Oakley Greenwood

External review of Heywood RIT-T

Project	Heywood RIT-T review
Client	Australian Energy Regulator
Status	Report
Report prepared by	G Thorpe
Date	August 2013

Figure 3 Central Scenario discounted benefits and costs by option

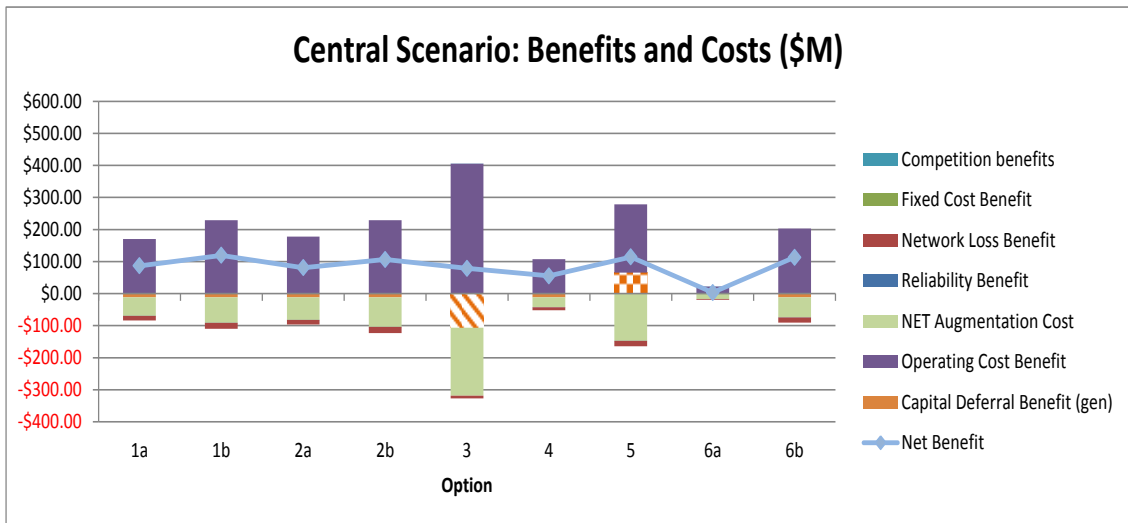
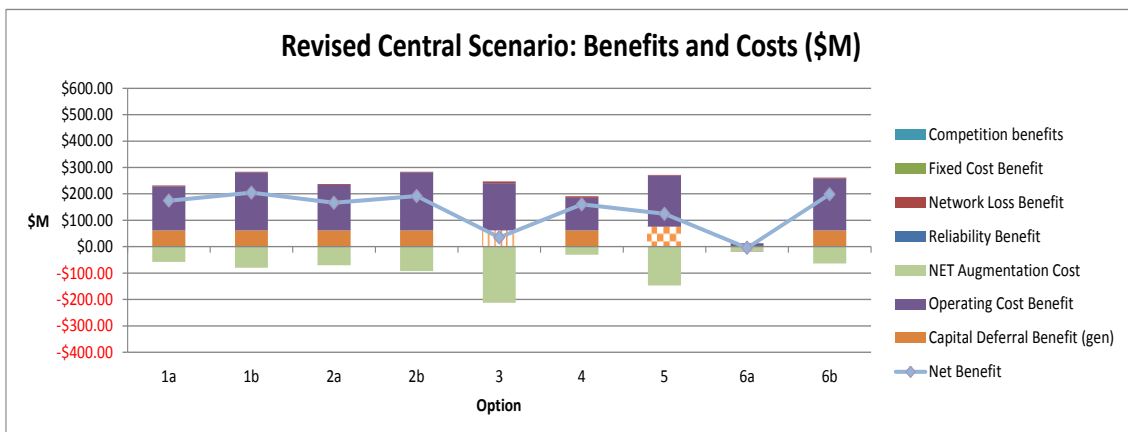
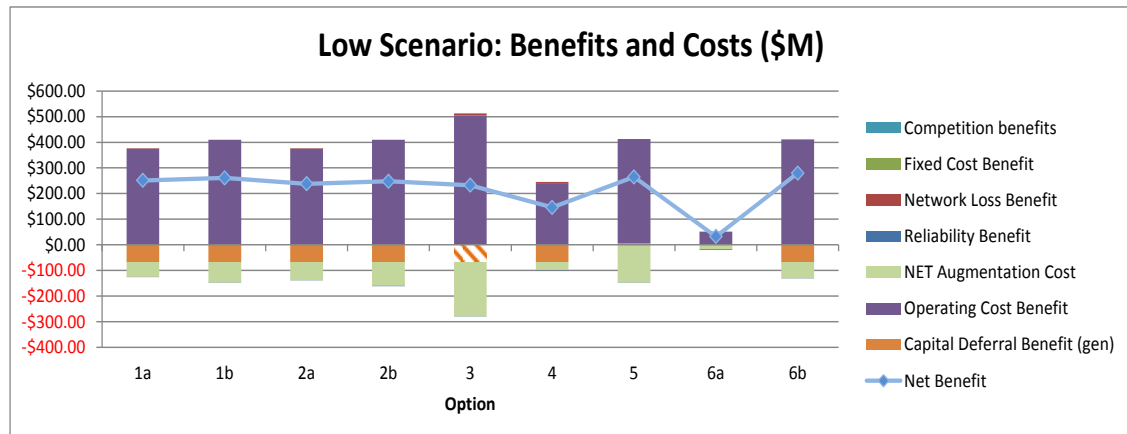
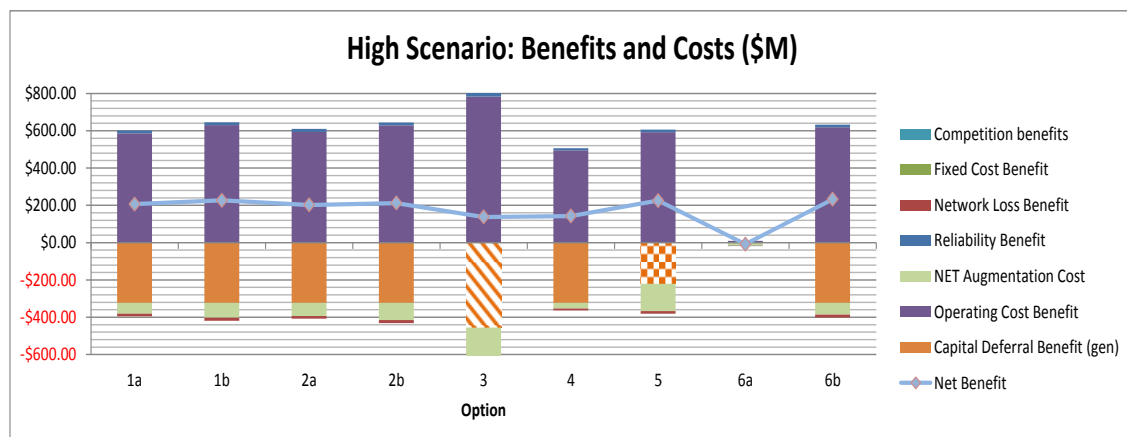
4. In respect of Option 3
 - a. This option creates a new and large greenfield flow path via Krongart. It involves substantial additional cost and may provide substantially higher market benefit. Review of Figure 3 through Figure 6 shows that while the gross benefits of this Option are likely to be higher in all scenarios its cost is markedly higher and thus net benefit less than the majority of other options. Option 3 therefore can be eliminated from further consideration.

Figure 7 Comparison of Option 1b and Option 4 operating cost benefit

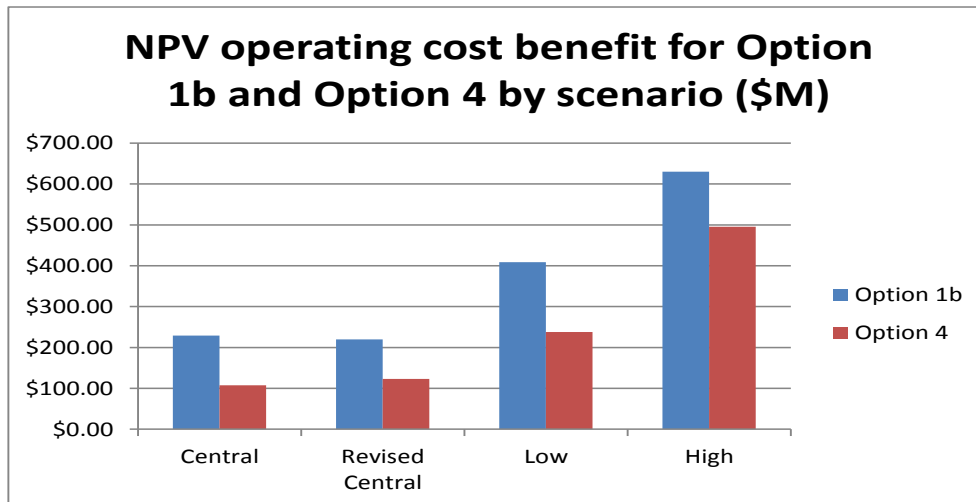
Using the logic just described, if operating costs are materially different, prima facie, investment schedules and costs may be different. It is notable that operating benefits are materially different with the largest gap appearing in the Revised Central Scenario where Option 4 benefit is only 56% of that of Option 1b as shown in Figure 7.

It is therefore relevant to ask if it is plausible that there would be approximately similar investment patterns. If there is doubt, a crucial question for this review is whether the differences are material in the sense that it would change which option provides maximum net benefit.

Figure 8 Comparison of Option 1b and Option 5 operating cost benefit

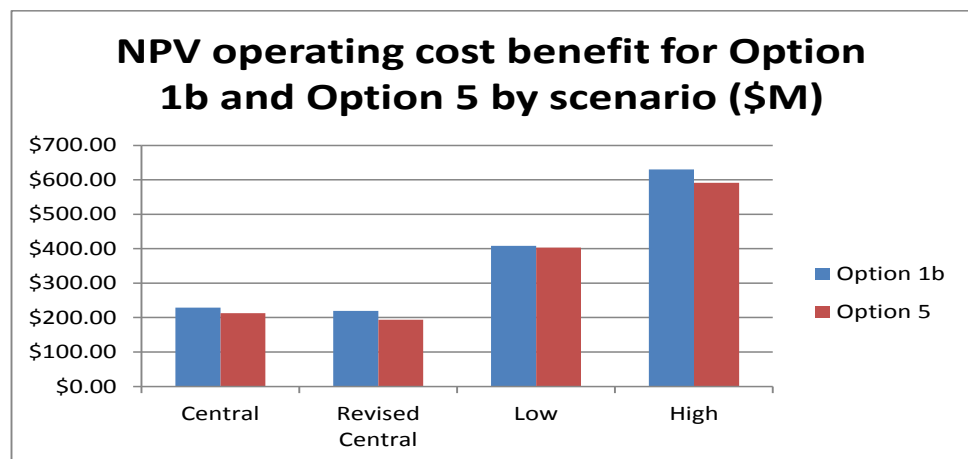
- h. In respect of operating cost benefit, it is notable that in all scenarios operating cost benefit of Option 5 tracks that of Option 1b, but is always a little less - see Figure 8. This result is to be expected as the dispatch cost assumed for the demand management program (\$750/MWh) is greater than that of an OCGT.
